**From:** Anil Reddy [REDACTED]  
**Sent:** Tuesday, December 03, 2013 12:35 PM  
**To:** Marion Pavan  
**Cc:** Janice Stern; Brian Dolan; Steve Otto  
**Subject:** Re: Summary

Date: August 17, 2012  
To: Bob Jones  
From: Ruby Hill ADC  
Re: Architectural Compliance  
Reddy Residence, Lot O-02 - 3737 W. Ruby Hill Drive

O-02      6896      3737 W. Ruby Hill      REDDY      Architectural  
Compliance

1. Concept Drawing (May 2010)
2. Approved Drawing (Jun 2010)
3. As-Built Drawing (May 2012)

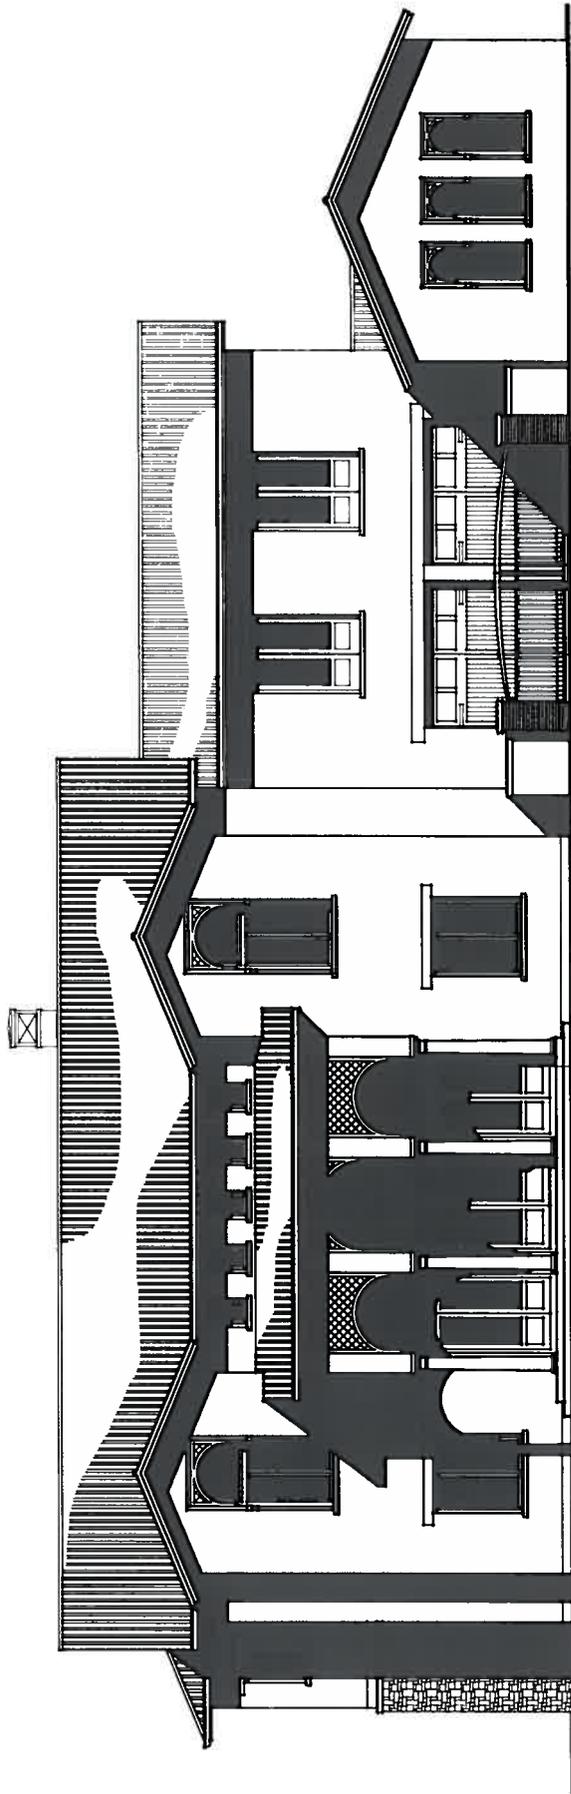
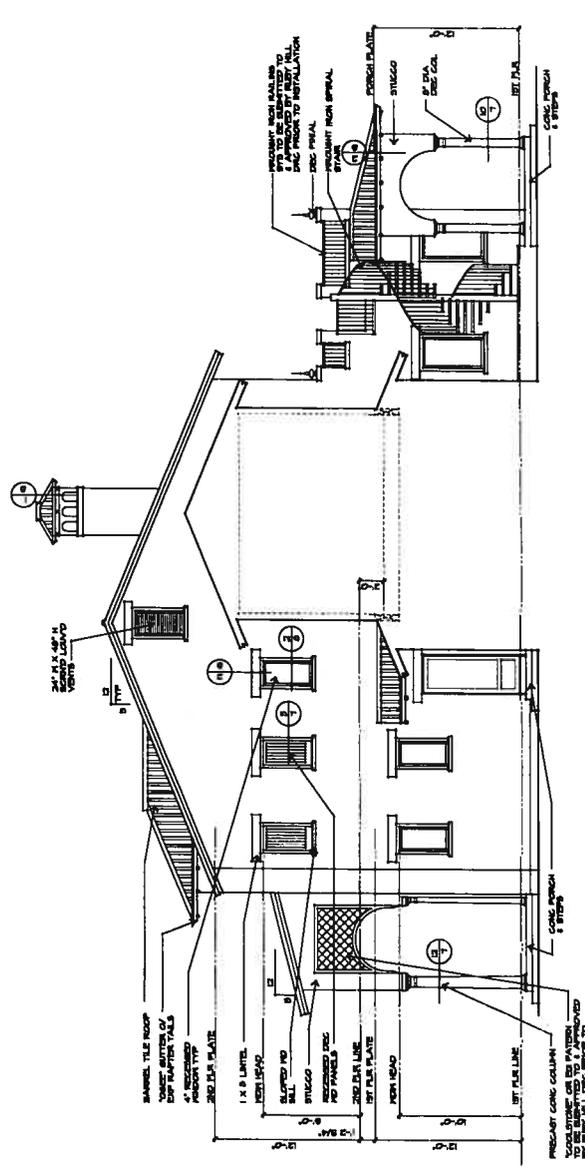
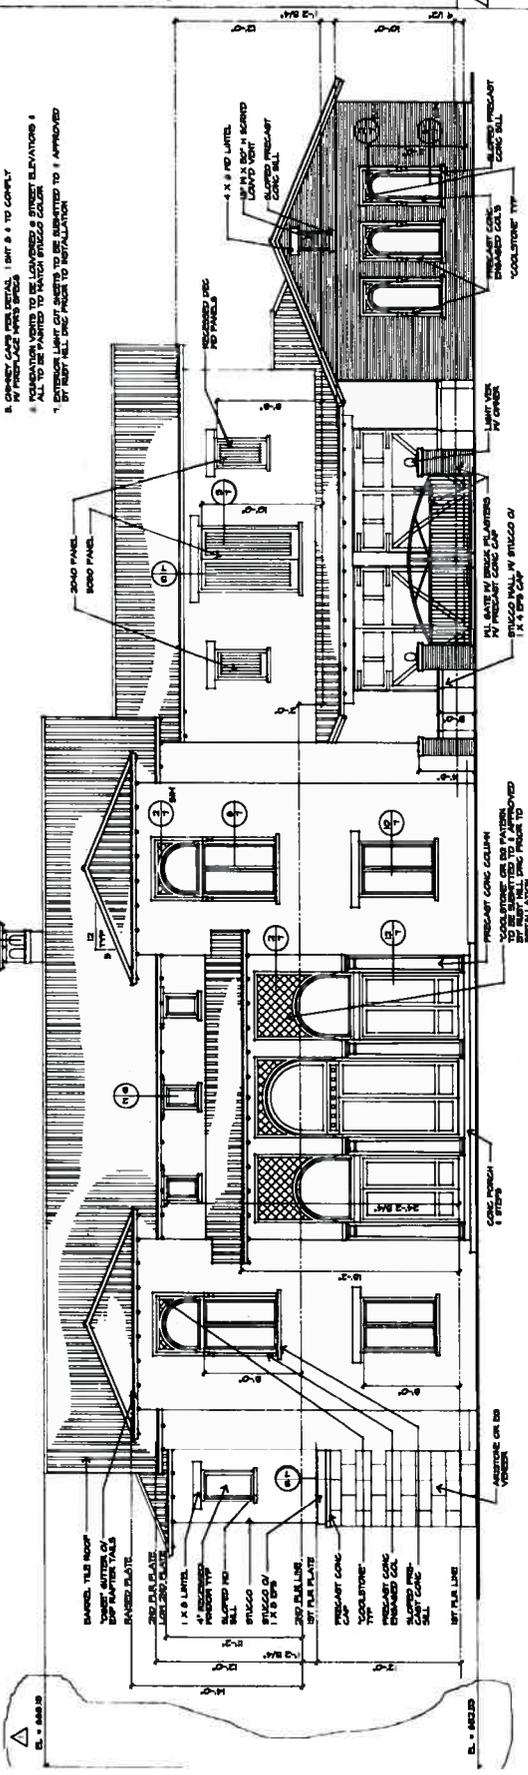
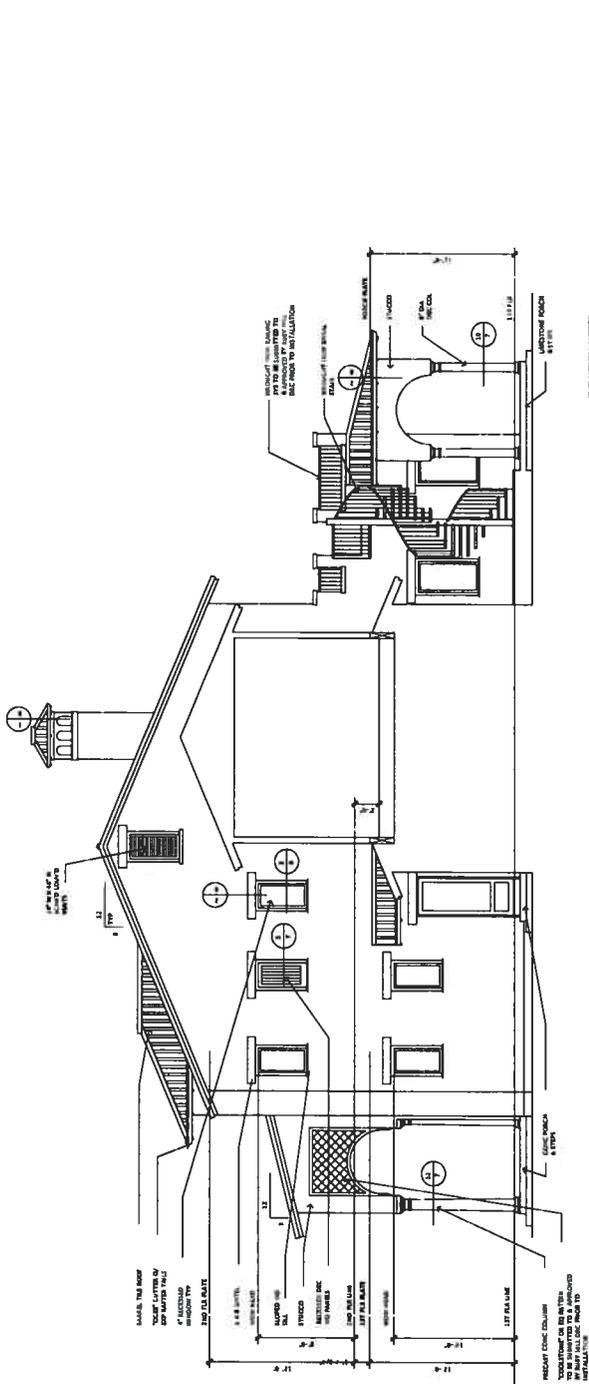
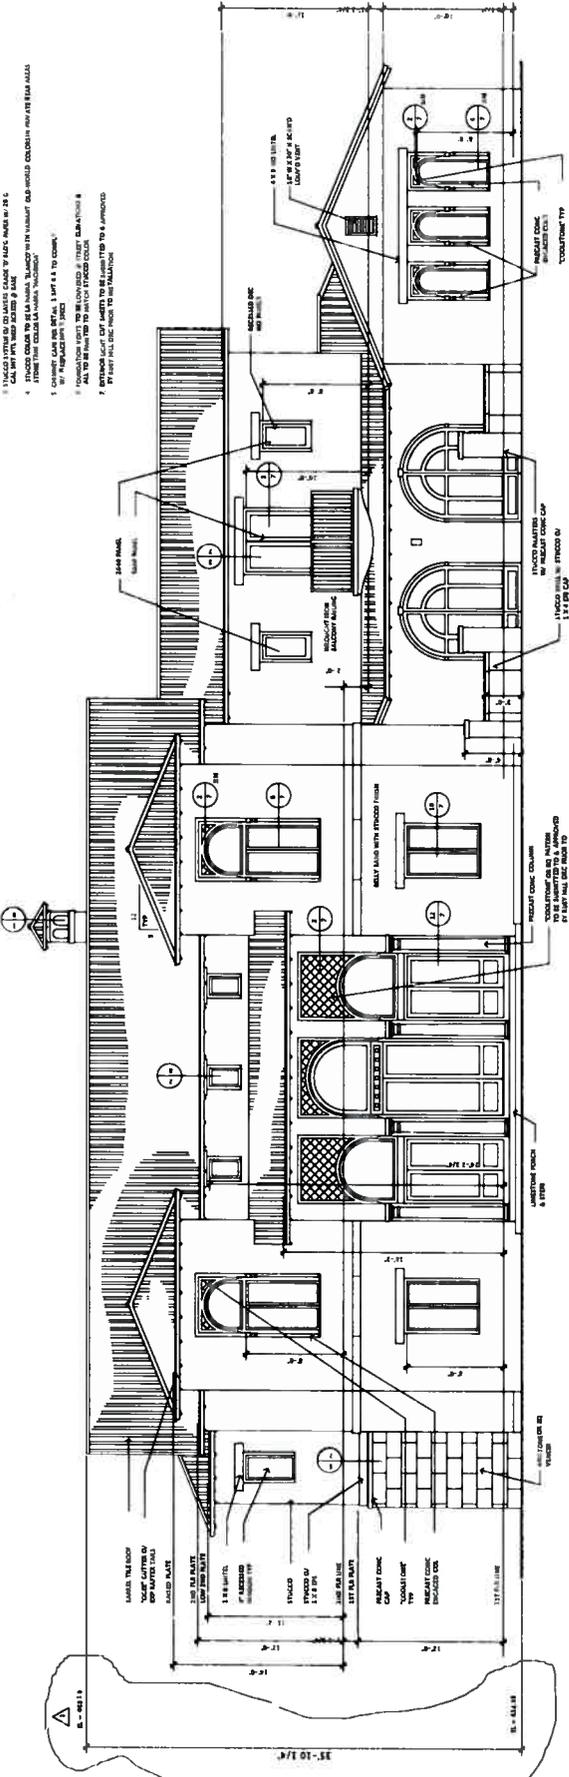
You can see that the as-built front elevation of May 2012 is remarkably close to the original concept drawing approved at pre-design conference of May 2010 and the approved plans of Jun 2010. The arch iron doors on Garage 1 were discussed at the start in 2010 as a welcome change more in keeping with the preference of the Guidelines that garages not face the street.
